SEATTLE ARENA

DOWNTOWN DESIGN REVIEW BOARD | RECOMMENDATION

PROJECT NUMBER: 301 4195 | 1700 FIRST AVENUE SOUTH

2.0 RESPONSE TO INITIAL RECOMMENDATIONS | 15

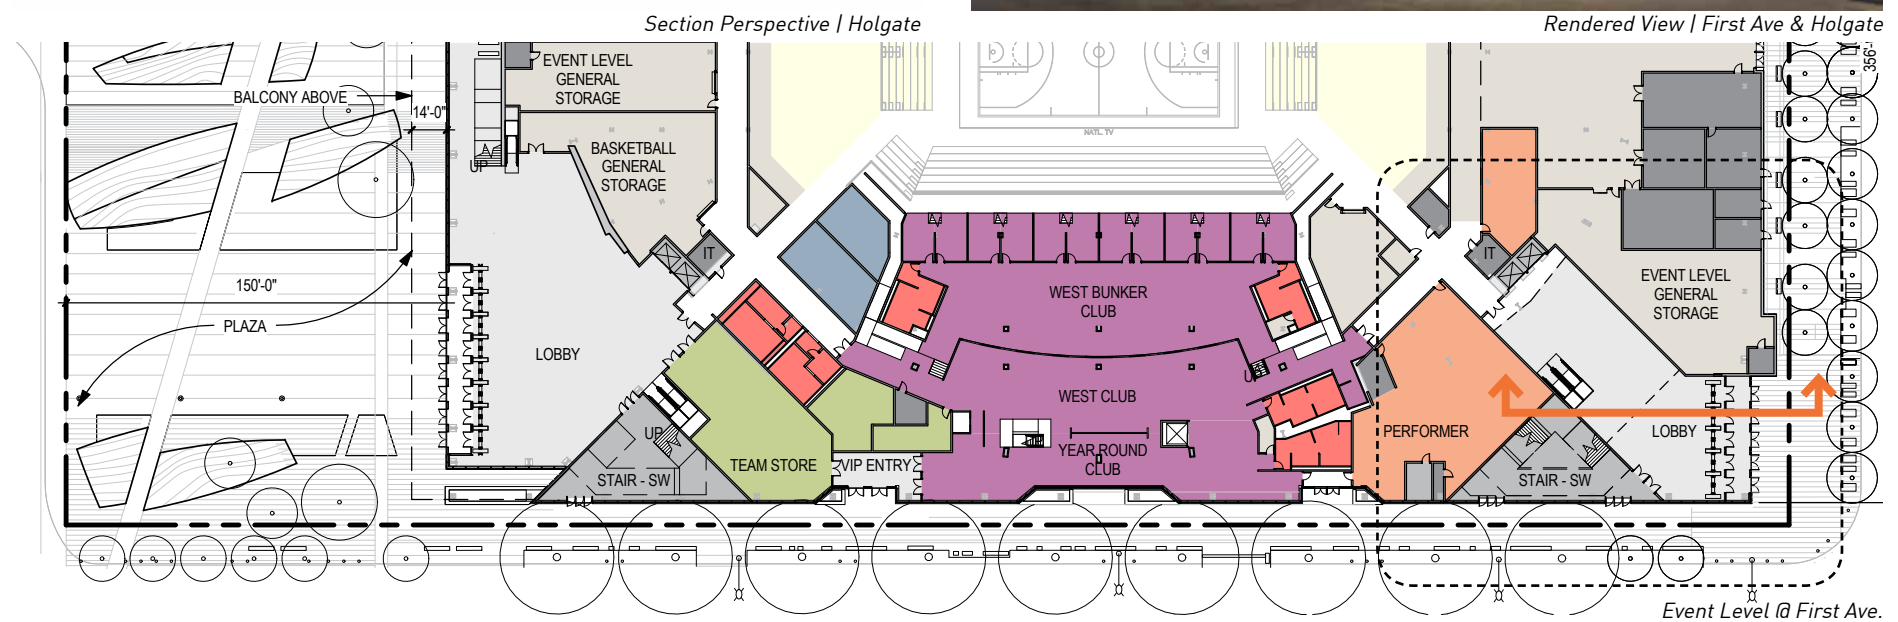
b) Southwest entry: The Board appreciated the lightening of the facade louvers at the entry corner (pg 54), but suggests it be more pronounced and possibly lift up fully to the +23ft high main concourse level, to better expose the tall lobby volume and the blades, and better signify entrance. The Board encouraged an increased north setback of the southwest entrance doors, further off the intersection. (C-1 and C-4)

- ROOF OVERHANGS
- CANOPY LOCATIONS

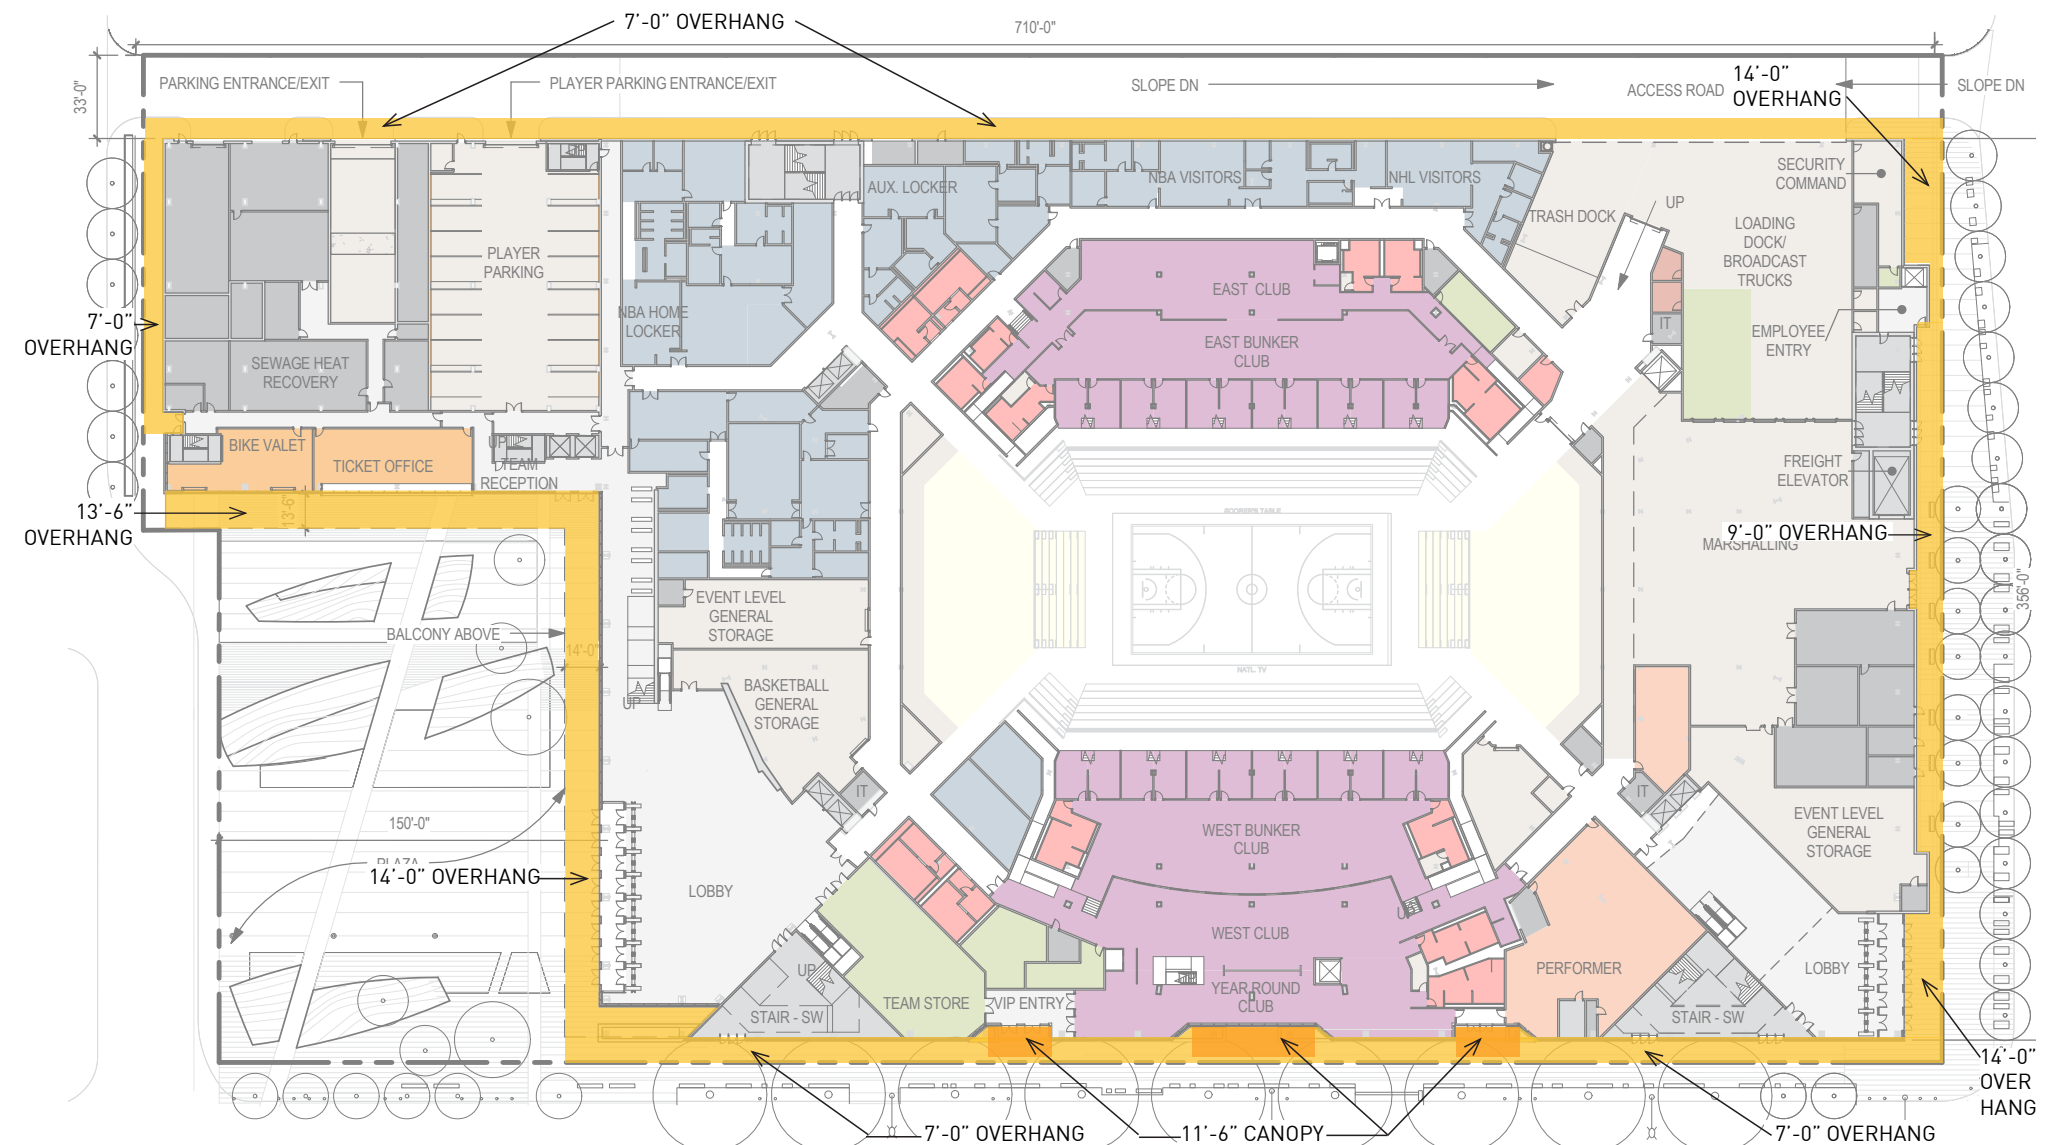
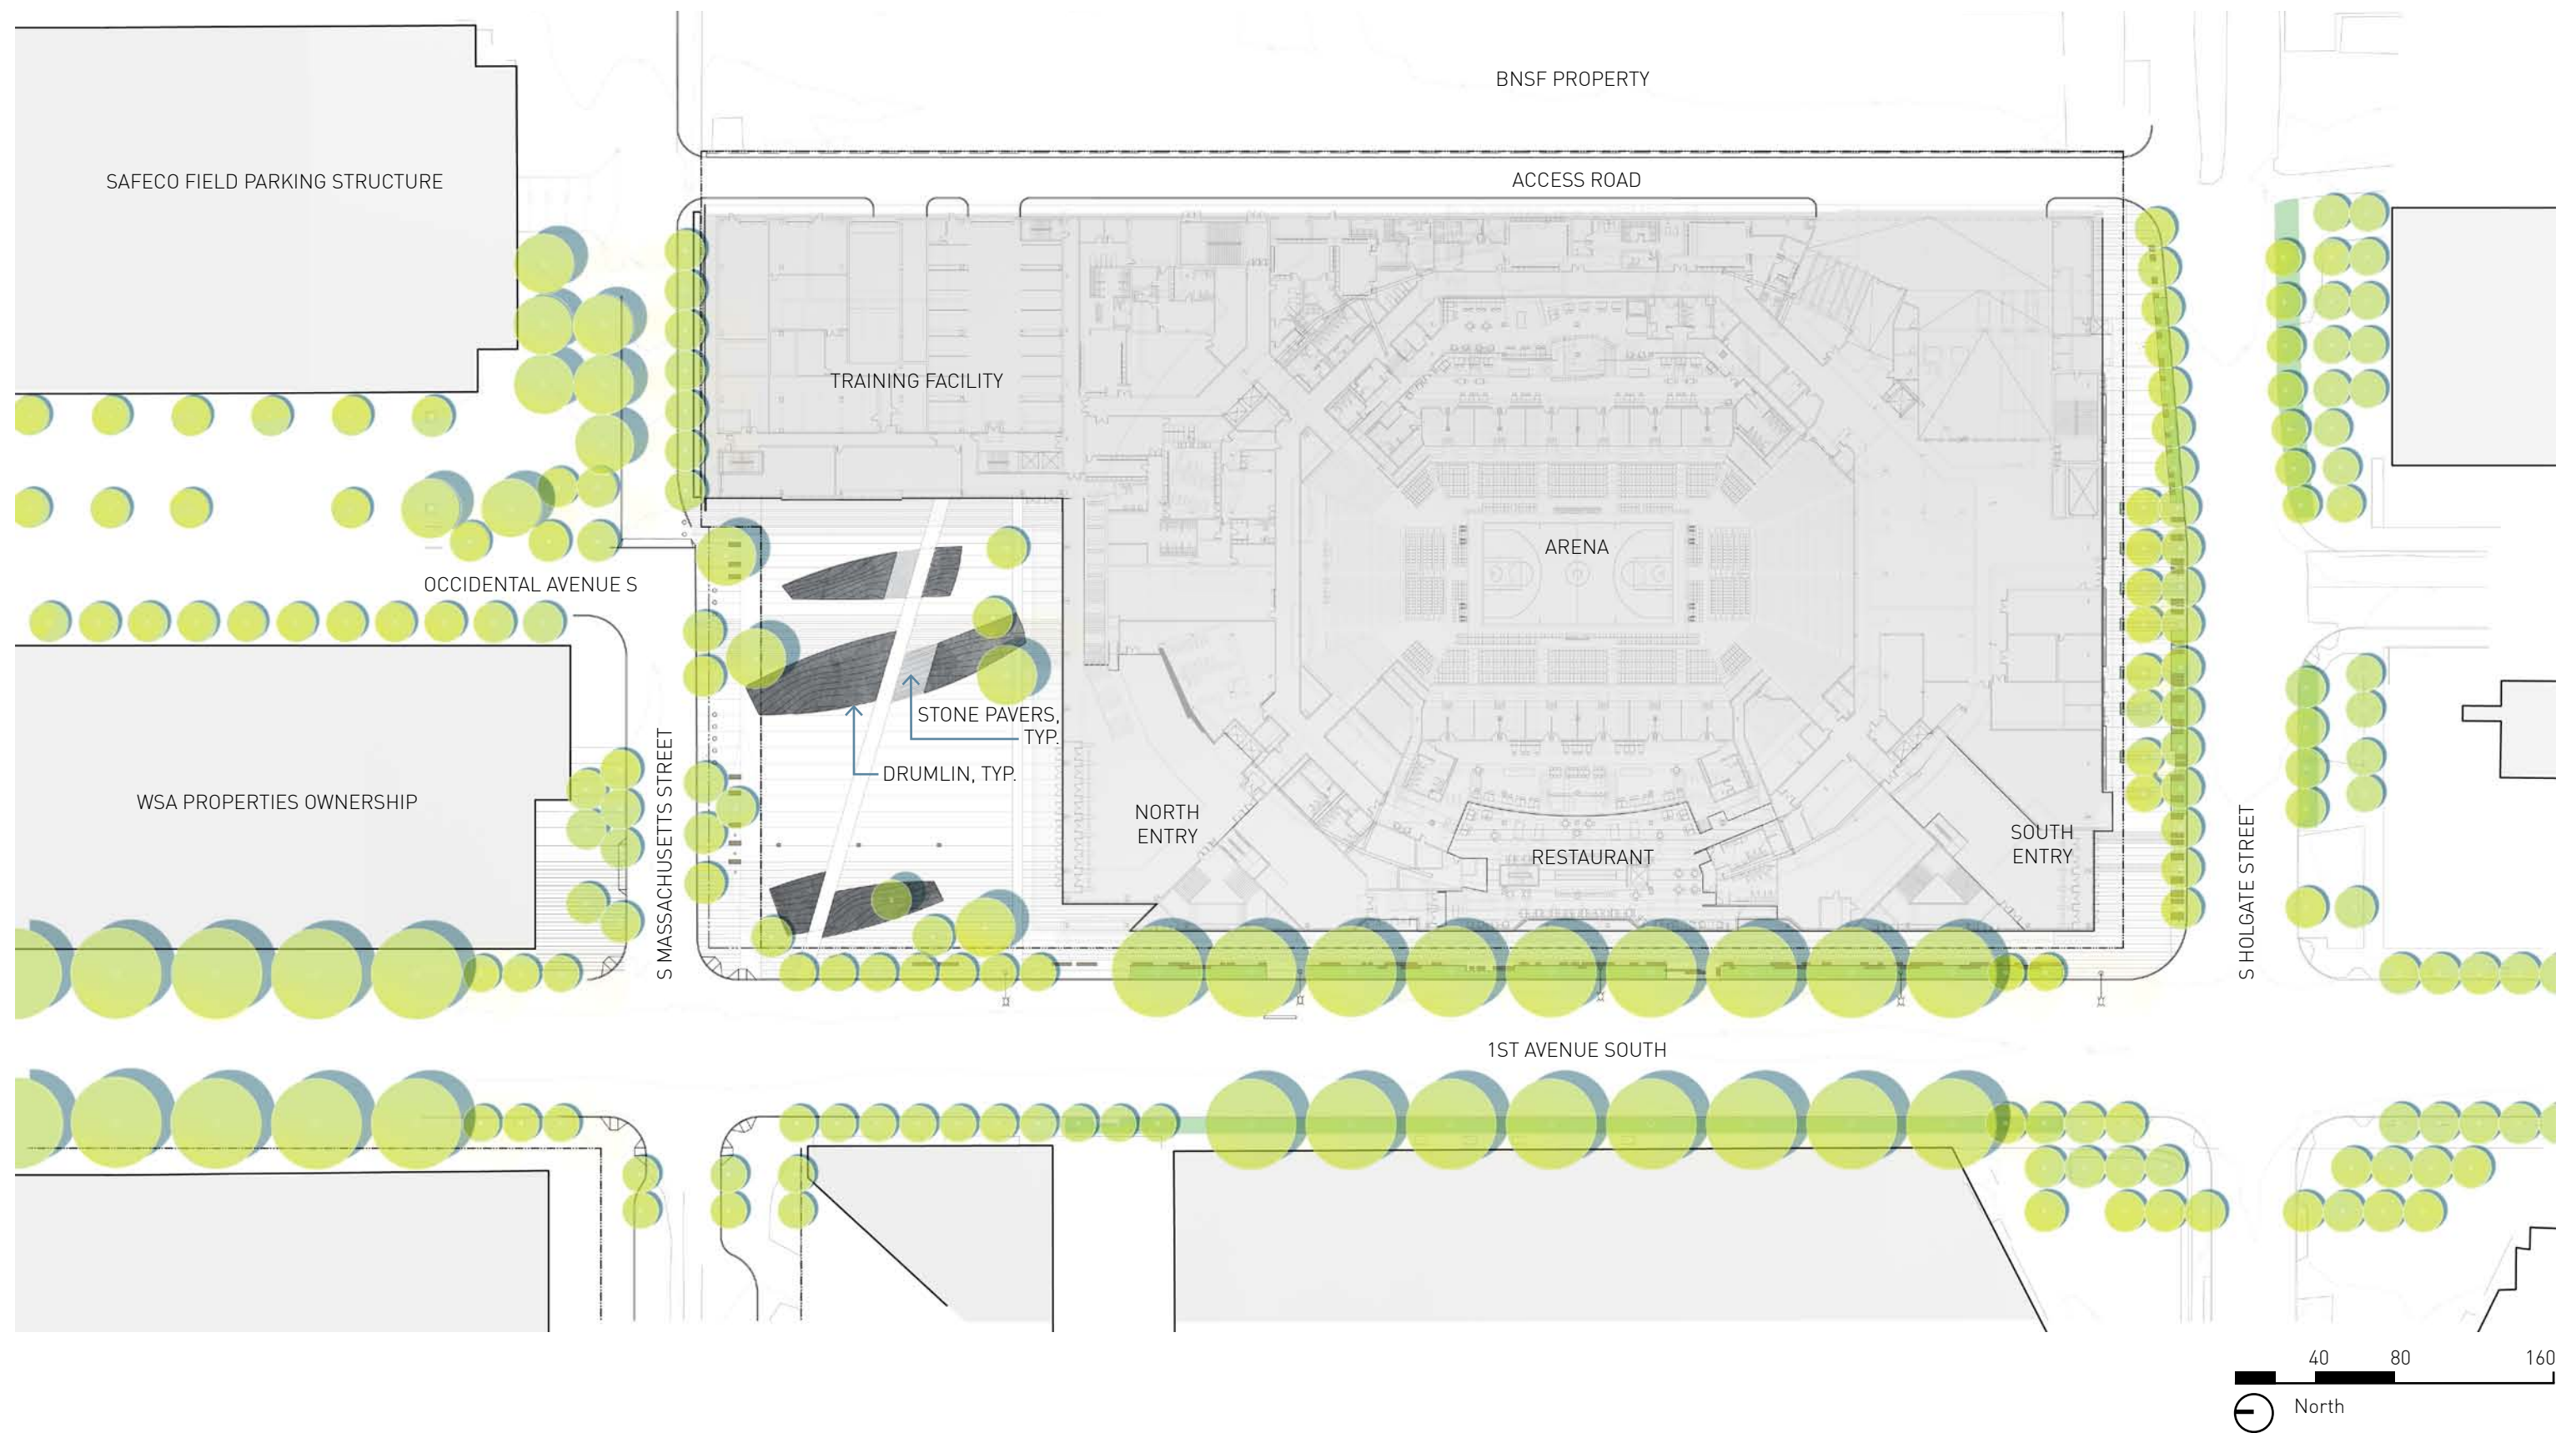
c) Weather protection: The Board agreed some weather protection on the plaza is valuable and should be studied further, but the sketch shown (incorporating the fin-wall) was too enclosing and too tall. They suggested canopies at several vertical levels, possibly trellis elements in the plaza itself, along the stair cut/ticket office, added to the upper terrace mechanical walls, and/or the existing north wall. Without reinforcing the mega-scale of the building, such canopies could also add human scale and signify the two banks of primary entrance doors, which are currently 'lost' in the planer glass of the north walls (see pg 39). (D-1 and C-5)

The design provides overhangs at the north plaza, south entry, south facade and along First Avenue for weather protection of arena entry, office entry, retail entry and ticketing.
